Model: V-C1		Date: 8-Feb-06	No.: RB700001
Subject: Euphrates finisher feed roller replacement		Prepared by: H.Matsui	
From: 2nd Tech Support Sec. Service Support Dept.			
Classification:	<input type="checkbox"/> Troubleshooting <input type="checkbox"/> Mechanical <input type="checkbox"/> Paper path <input type="checkbox"/> Product Safety	<input type="checkbox"/> Part information <input type="checkbox"/> Electrical <input type="checkbox"/> Transmit/receive <input type="checkbox"/> Other ()	<input type="checkbox"/> Action required <input type="checkbox"/> Service manual revision <input checked="" type="checkbox"/> Retrofit information

Procedure for Replacing the B7002491 Exit Roller

Model: V-C1/MT-C3 Finisher (SR970/980/4000)	Date: 28-Feb-06	No.: RB700002b
---	-----------------	----------------

Model: Model V-C1 Finisher	Date: 11-May-06	No.: RB700003
----------------------------	-----------------	---------------

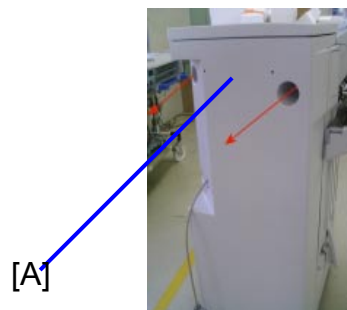
2. Check the barcode label on the finisher’s box.

- If the label does not have a round marking [A], continue with this procedure.
- If the label has a round marking [A], stop this procedure.
Note: The exit rollers were already replaced on finishers that have this round marking.

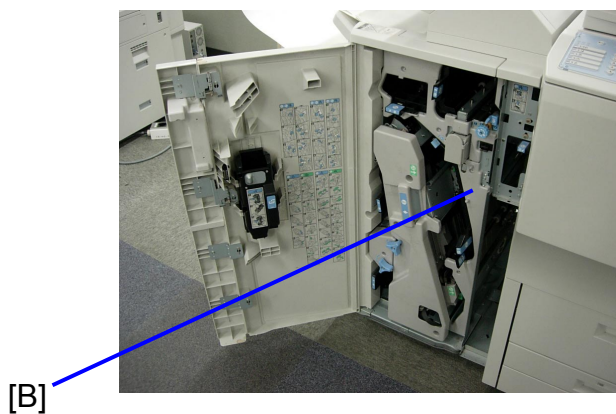
3. Remove the finisher rear cover [A] (2 screws, 2 hooks).

[C]

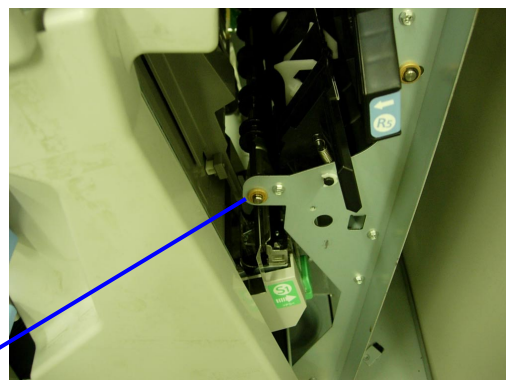
5. Remove the feed roller bushing [C] (1 E-ring).

[D]

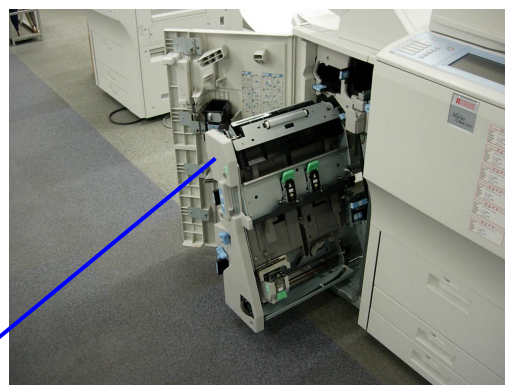
6. Pull out the staple unit [D].

[E]

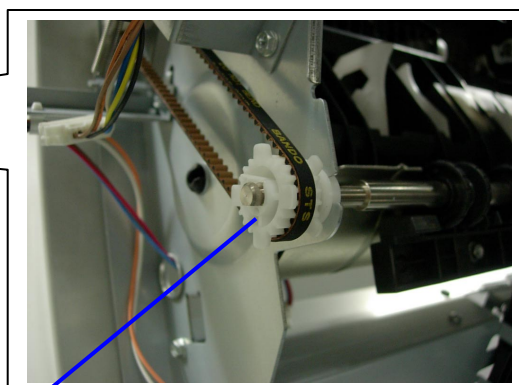
7. Remove the timing pulley [E] (1-nail hook).

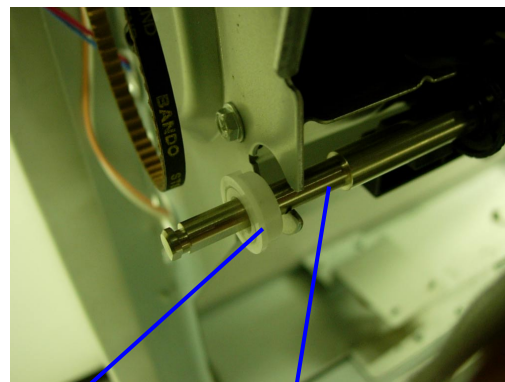
8. Remove the bushing [F], then remove the defective feed roller [G].

[H]

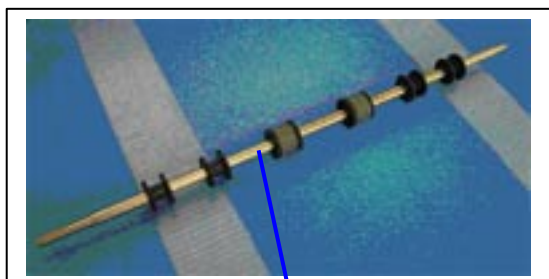
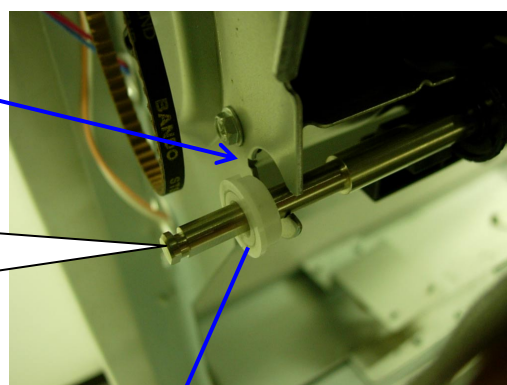
9. Install the new feed rollers [H].

Important: Put the hook of the bushing [I] into the cut-out in the bracket [J].

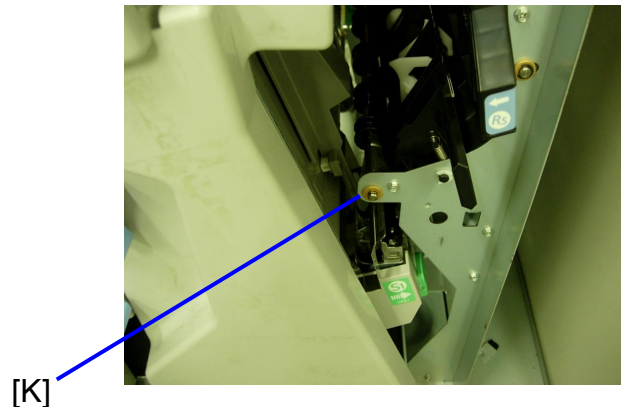
10. Reattach the bushing [K] to the front side bracket (1 E-ring).

11. Put the timing belt [L] around the timing pulley [M].

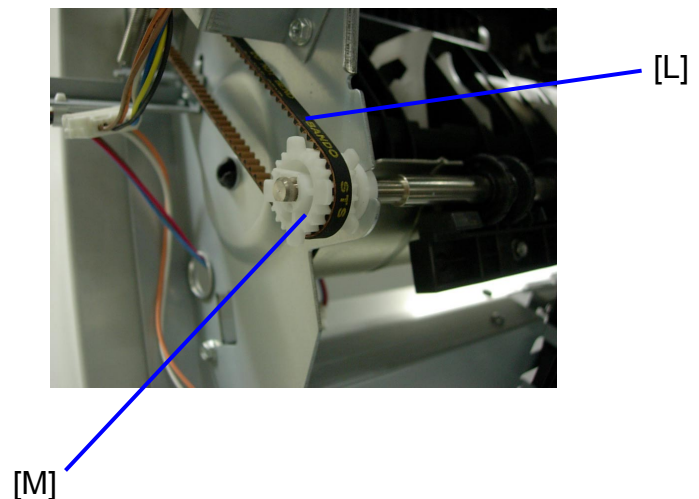
12. Install the timing belt and timing pulley together.

- Make sure to slide the pulley onto the shaft until the hook of the pulley clicks into place.
- After you install the pulley and belt, make sure that the timing belt is on the flat area of the pulley.

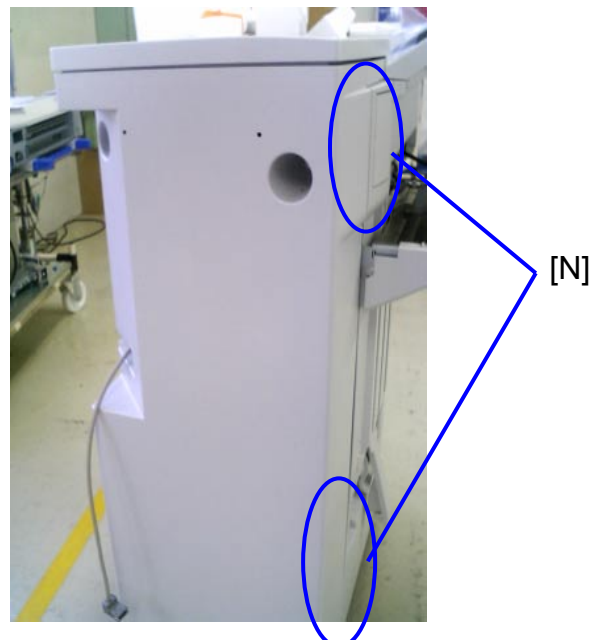
Important: Make sure to put all of the tabs on the rear cover into the correct openings in the finisher (especially in the areas marked "[N]").

12.Staple Tray 5 (B700/B701)

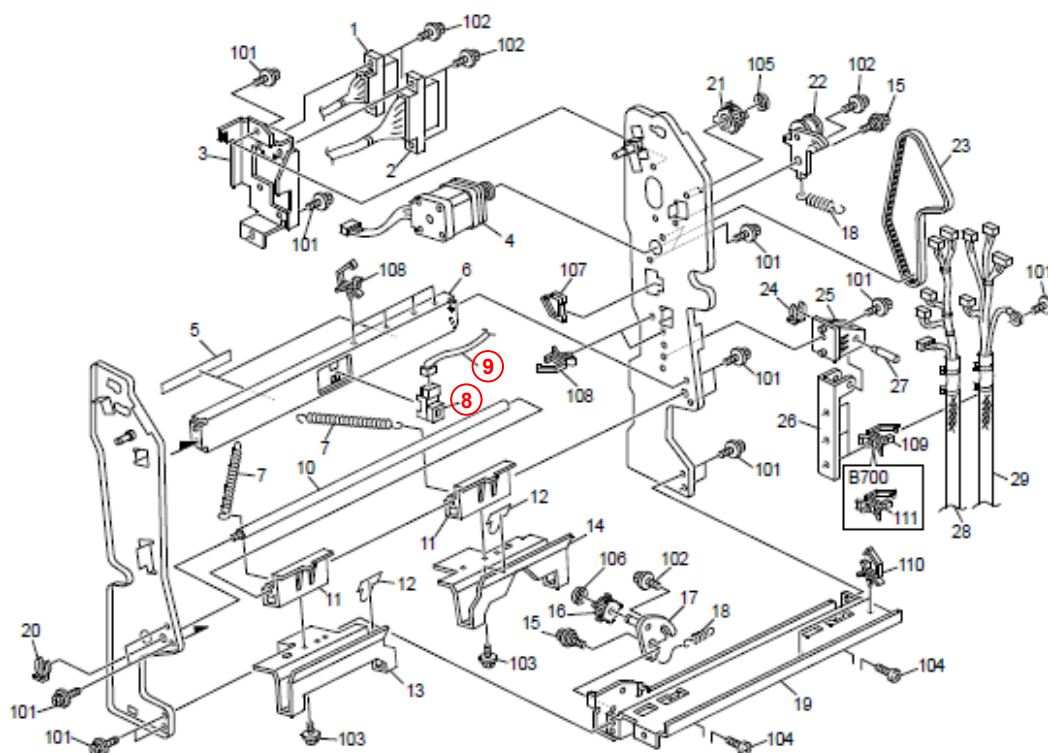
The illustration was corrected as shown below (index numbers 8 and 9 were reversed).

8	GW01 0007	Photo Refiection Sensor:Exit
9	B700 5419	Harness:Connecting:Sensor

1.Punch Unit 1 (B702)

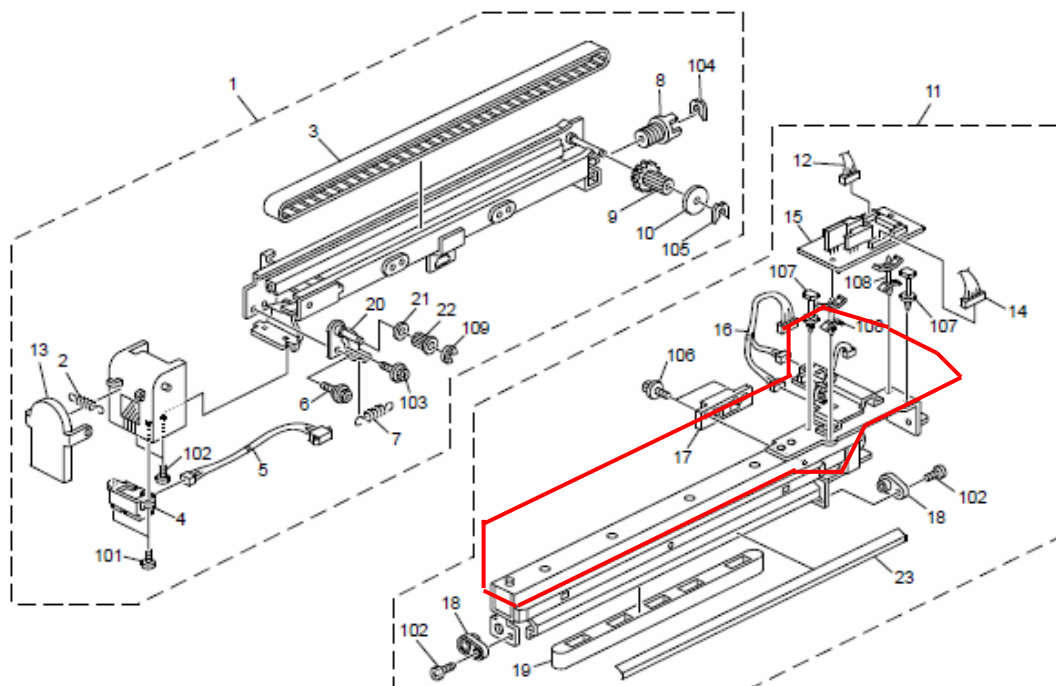
Change: The punch unit assembly was added (circled in red in the illustration).

Reason: To enable the assembly to be replaced in the field.

Important: The component parts of the assembly, such as the motor, cannot be replaced individually in the field. This is because they can only be removed and installed using specialized equipment at the factory.

10.Staple Tray 3 (B700/B701)

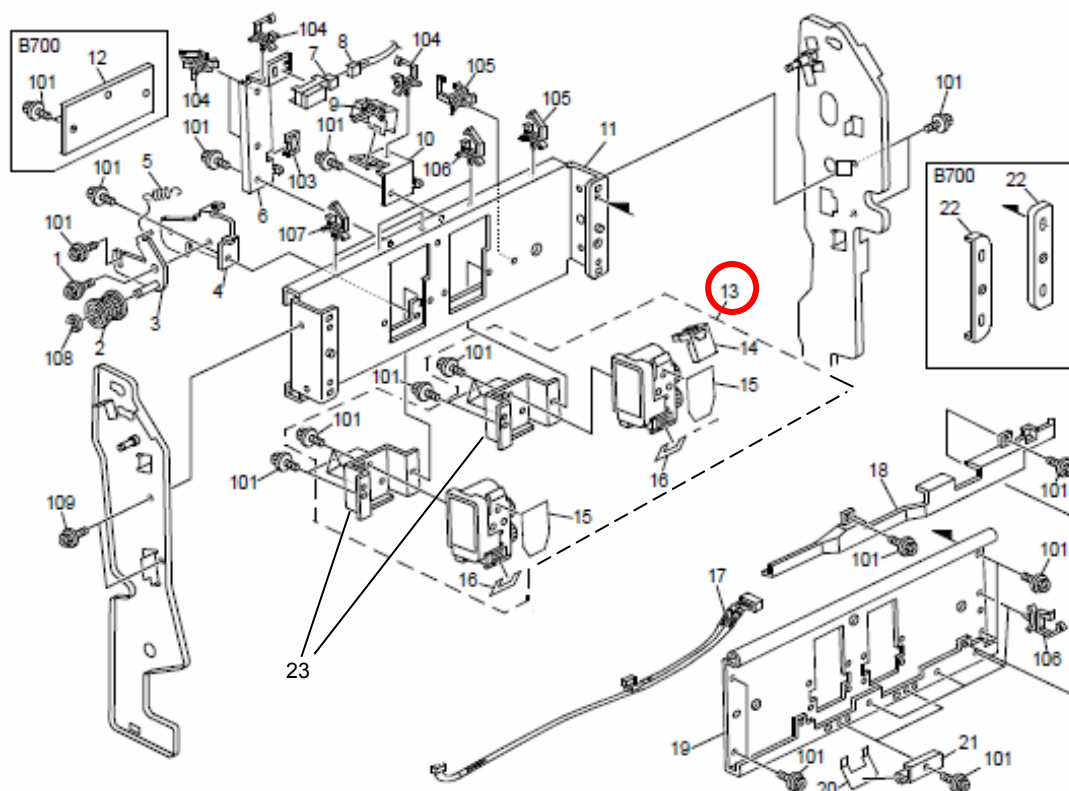
The illustration has been modified.

The part B7007852 (Pg.21, Index#13) doesn't contain a staple.

2.Punch Unit 2 (B702)

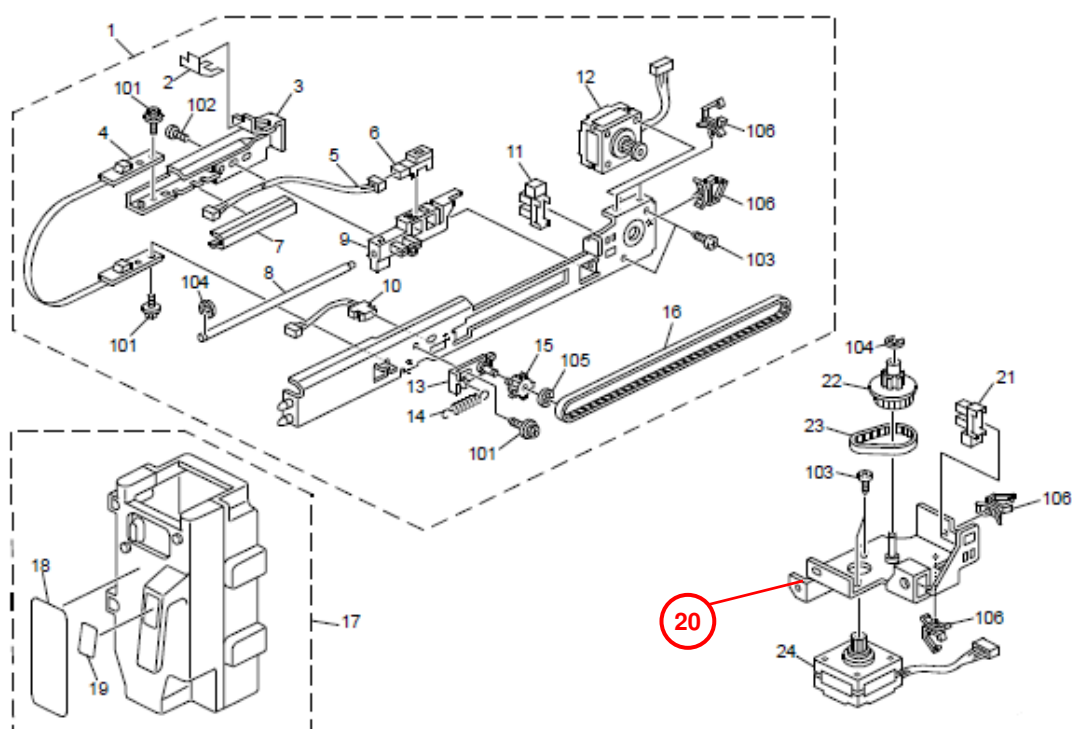
Illustration has been modified.

Stapler Tray (pg. 23, index #17)

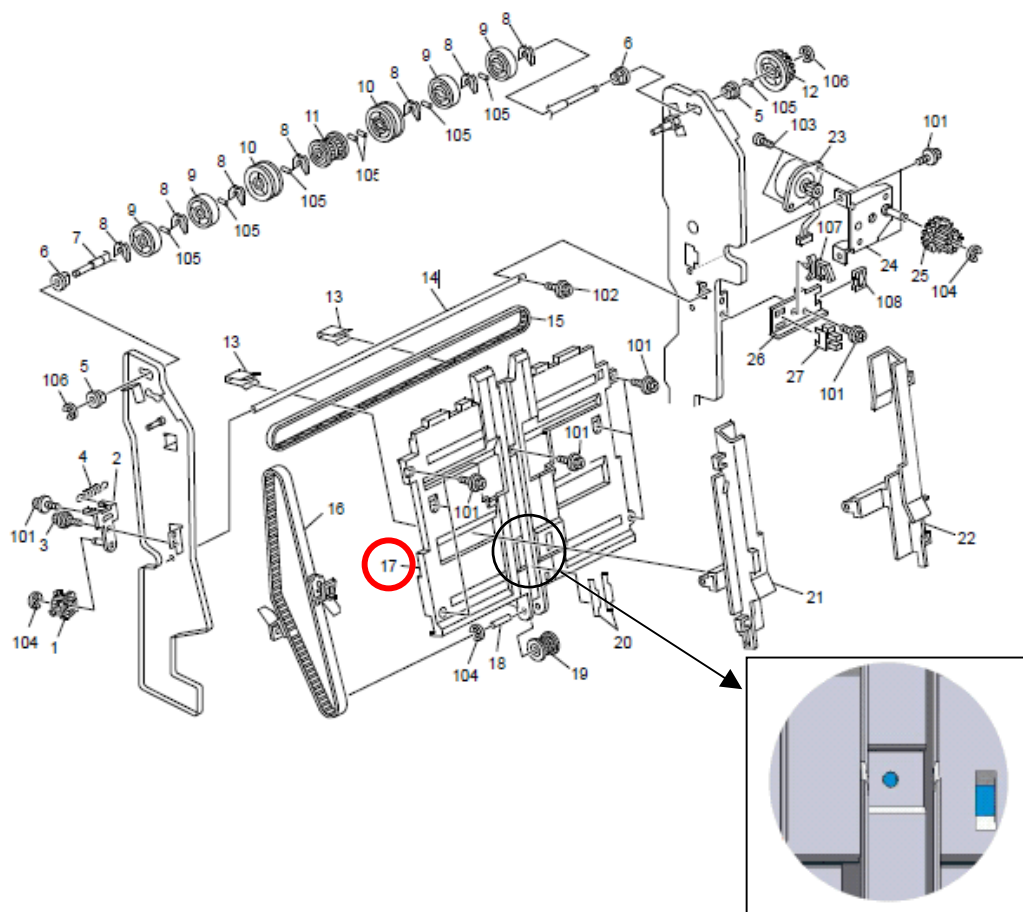
Change: A tapping screw was added for attaching the stapler tray to the lower stay positioning sensor, and screw holes were added as shown below.

Reason: To further improve structural reliability.

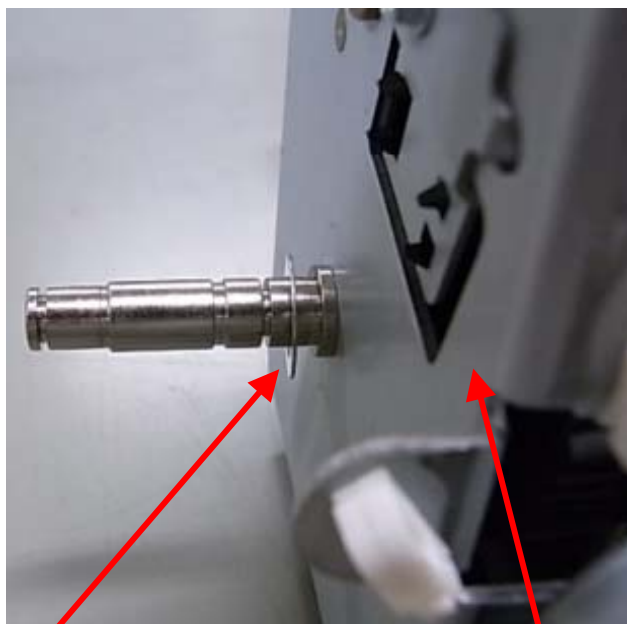
Change:New part (SPACER - 10.5/16) has been added.

Reason:.To improve reliability of stapling.

Index#113
08077092 (SPACER - 10.5/16)

Index#15
D3734320 (BRACKET:STAPLER:SLIDE:ASS'Y)

12.Staple Tray 5 (B70057)

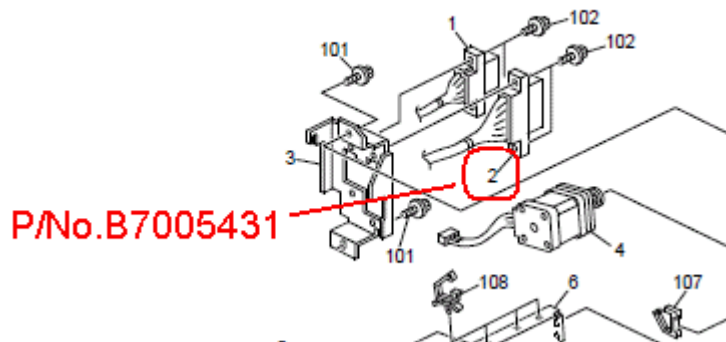
Change/Reason: The part numbers in the table were corrected as shown above.

Incorrect part number	Correct part number	Description	Q'ty	Int	Page	Index	Note
B700-5430	B700 5431	Harness - Staple			25	2	
B700-5340	B700 5430	Harness - Stapler			47	13	
B700-5431	B700 5340	Harness - Staple Tray Unit			47	14
